Access Compliance Report

Public Rights-of-Way

(Curb Ramps)

Intersection ID: 50867	Main Street: REAMES_RD	Cross Street: BROOKLINE_RIDGE_DR	Location: SW
ADA ID: 9533A2655783	Ramp Type: Perp	Initial Pass/Fail: Fail	Overall Compliance: No
Severity Score: 21.25			
Codes/Mitigation Info/Possible Solution		Field Measurements/Component Compliance

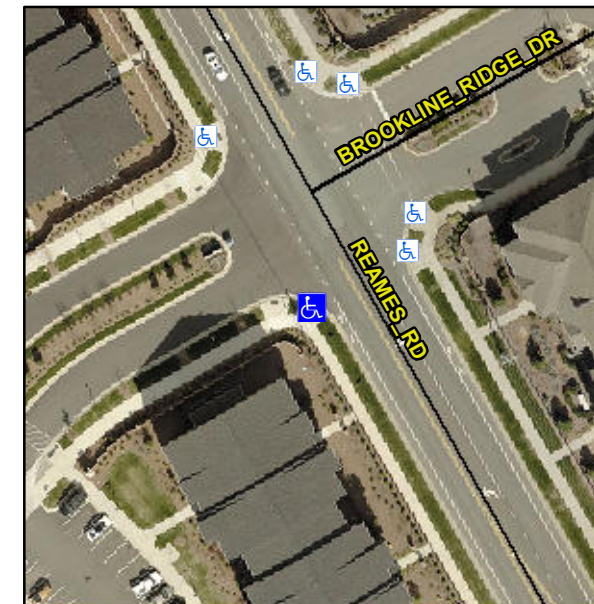
Not Found, R304.5.1, R304.2.2

Compliance	Description	Data	Compliance	Description	Data
N/A	Ramp Length (in)	73.0	No	Ramp Slope (%)	9.4
No	Ramp Width (in)	46.5	Yes	Ramp XSlope (%)	0.8
N/A	Flare Type LT	N/A	N/A	Flare Type RT	N/A
N/A	Flare Slope LT (%)	N/A	N/A	Flare Slope RT (%)	N/A
N/A	Flare Traversable LT?	N/A	N/A	Flare Traversable RT?	N/A
N/A	Landing Length (in)	N/A	N/A	DWS Provided?	N/A
N/A	Landing Width (in)	N/A	N/A	DWS Contrast?	N/A
N/A	Landing Slope (%)	N/A	N/A	DWS Length (in)	N/A
N/A	Landing X Slope (%)	N/A	N/A	DWS Full Width?	N/A
N/A	Landing Curb? (Y/N)	N/A	N/A	DWS Offset (in)	N/A
N/A	Shared Landing?	N/A			
N/A	Gutter Ponding?	N/A	N/A	Gutter Slope (%)	N/A
N/A	Gutter Lip Ht (in)	N/A	N/A	Gutter X Slope (%)	N/A
N/A	Painted X Walk1?	No	N/A	Painted X Walk2?	N/A
	X Walk 1 Direction	To E		X Walk 2 Direction	N/A
N/A	X Walk 1 Width (in)	N/A	N/A	X Walk 2 Width (in)	N/A
	X Walk 1 Slope (%)	2.5		X Walk 2 Slope (%)	N/A
	X Walk 1 X Slope (%)	0.5		X Walk 2 X Slope (%)	N/A

Remove & Replace Entire Ramp.
